Product Change Notification

Change Notification #: 112753 - 00
Change Title: Intel® Server System R2208BB4GC and R2224BB4GCSAS
PCN 112753-00, Product Design Update System PSU Bracket
Date of Publication: November 25, 2013

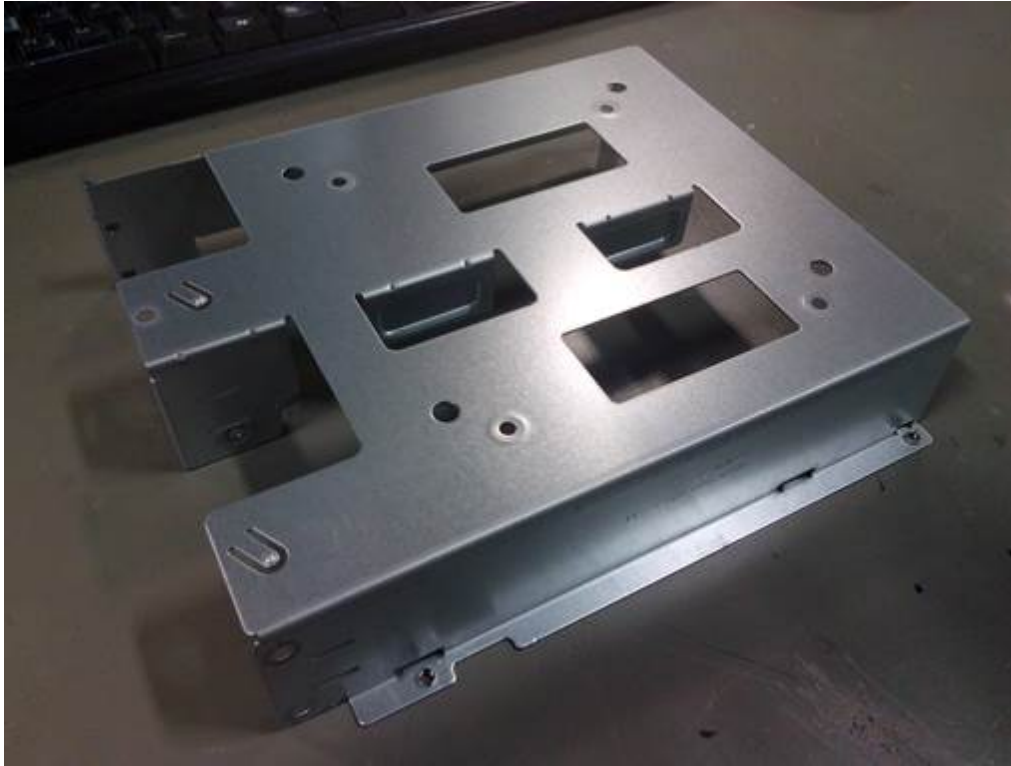
Update the Power Supply bracket to remove middle punch. Please refer to below pictures for details:
